Subject: Comments in Reply to Questions Raised by Various Agencies
on the AEC Draft Detailed Statement
Oconee Nuclear Station
AEC Docket Nos. 50-269, -270, and -287

This is to supplement our letters of February 11 and 16, 1972 in reply to your letter transmitting comments in connection with the Oconee Unit 1 Draft Environmental Statement issued December 13, 1971.

2-23-72 EO-1100-24

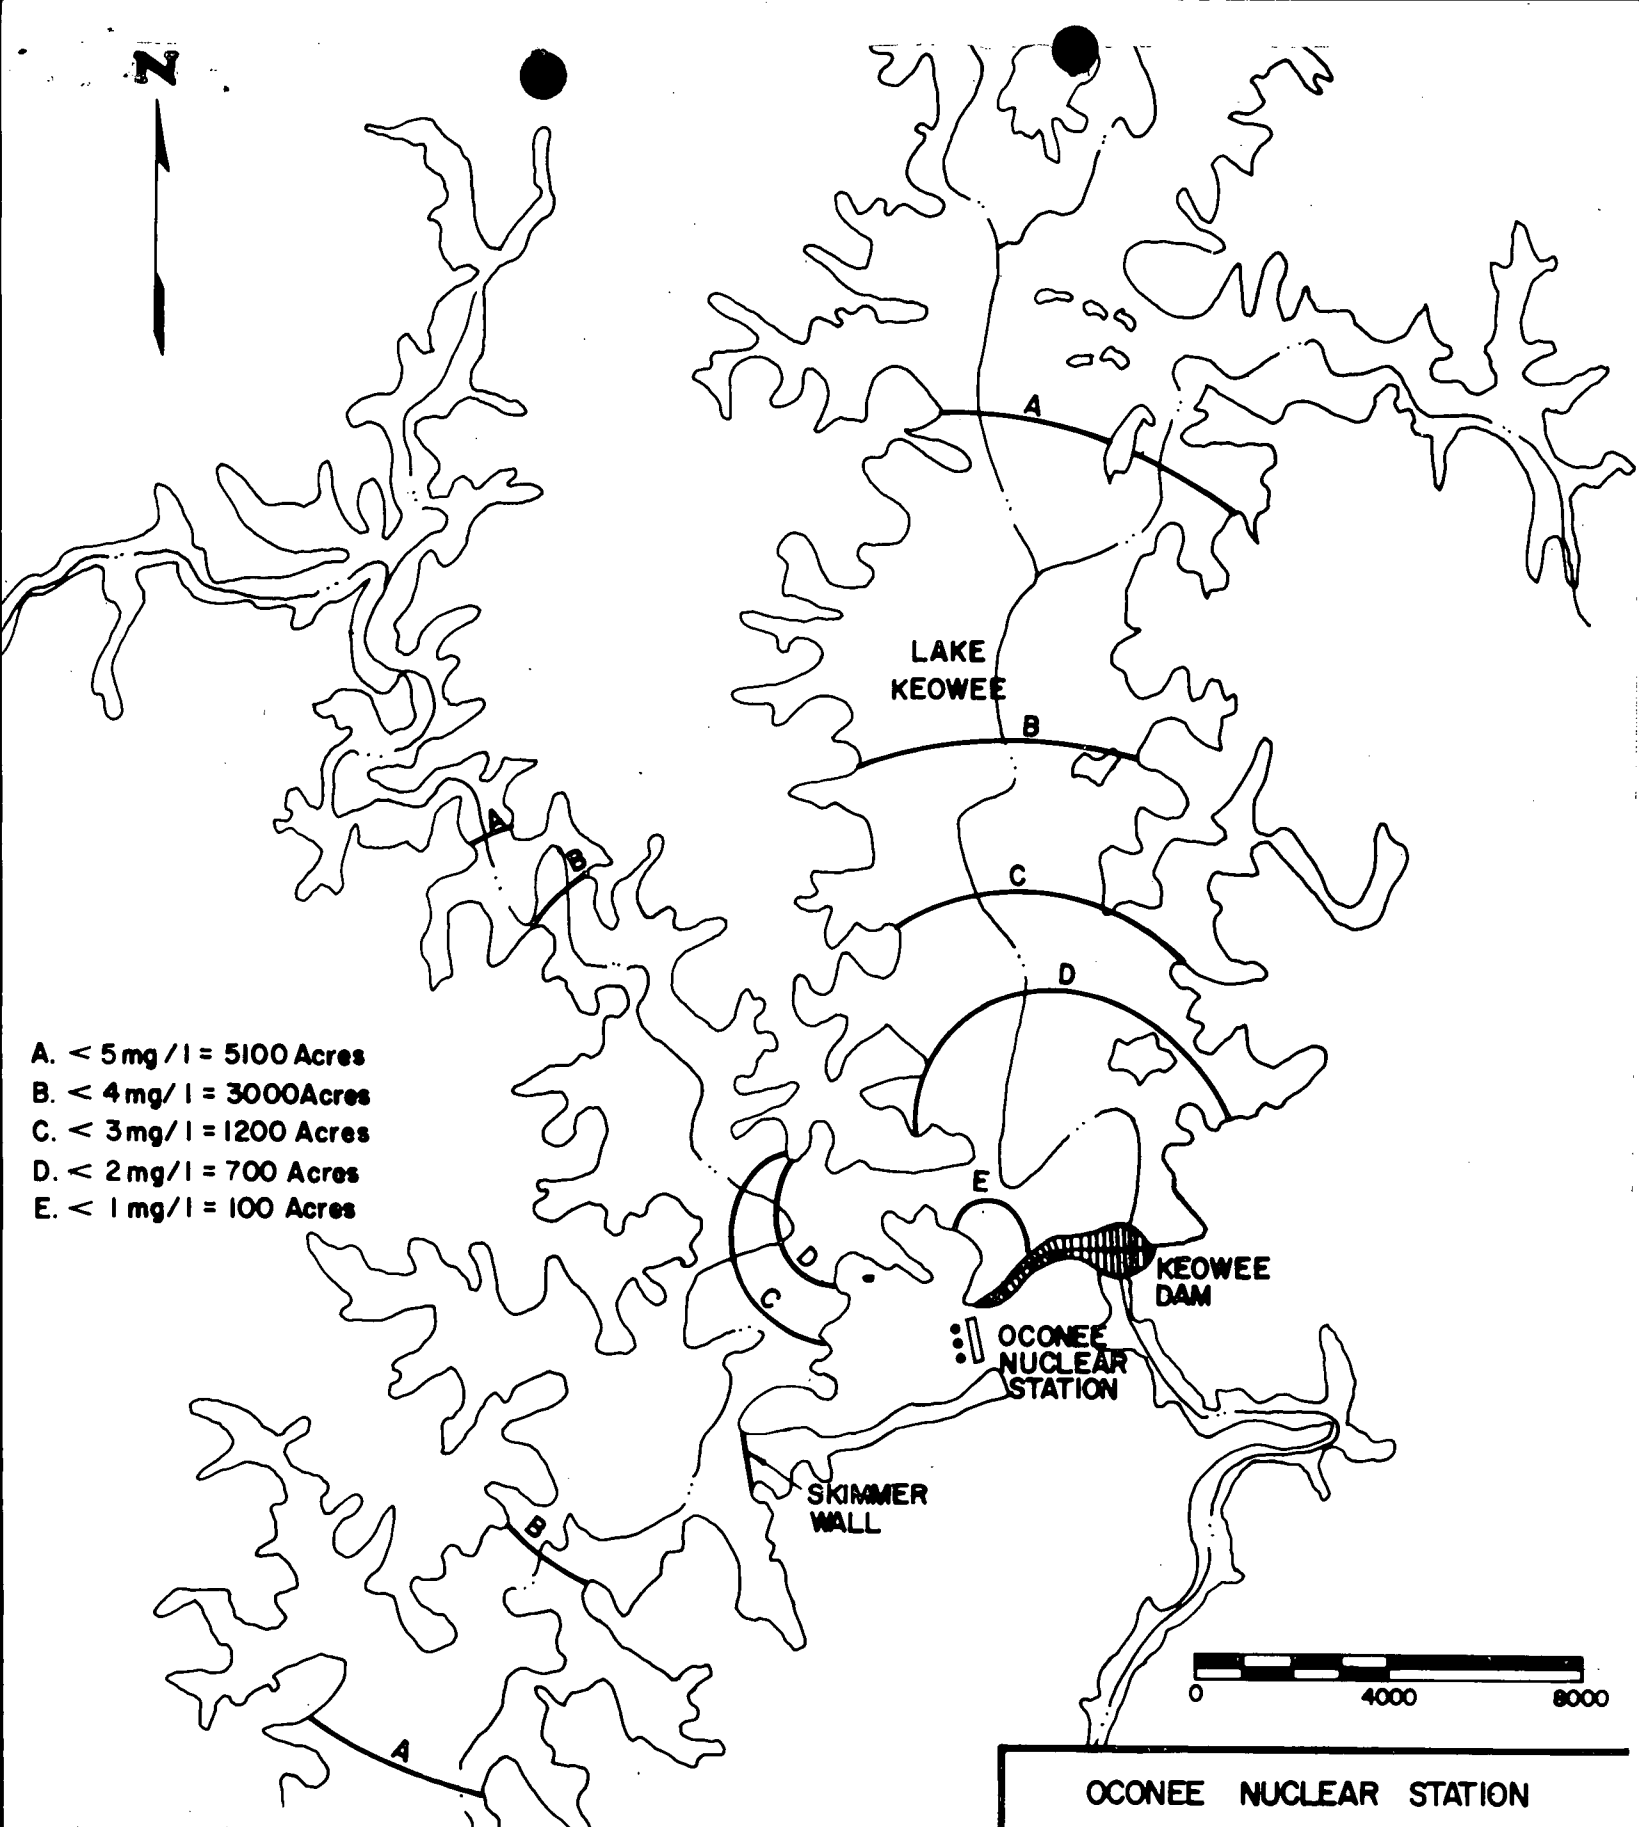
Our response to the concerns of the Environmental Protection Agency relating to the effect of Oconee Nuclear Station on the dissolved oxygen concentrations in Lake Keowee as expressed on Pages 17, 18, and 19 of comments attached to their letter of January 20, 1972 addressed to Mr. Manning Muntzing are as follows:

Average Conditions - (Drawing EO-1100-24) (Attached)

This drawing presents isopleths of DO and areas which represent the average (expected) conditions during the worst month of the year in Lake Keowee due to the influence of Oconee Nuclear Station. The area with concentrations less than 1 mg/l is 100 acres with average depth of four feet; concentrations less than 2 mg/l will prevail over 700 acres to average depth of two feet; 3 mg/l, 1200 acres, four feet; 4 mg/l, 2100 acres, seven feet. Three thousand (3000) acres are expected to have less than 5 mg/l and this will extend down into the zone of the lake where natural concentrations are less than 5 mg/l.
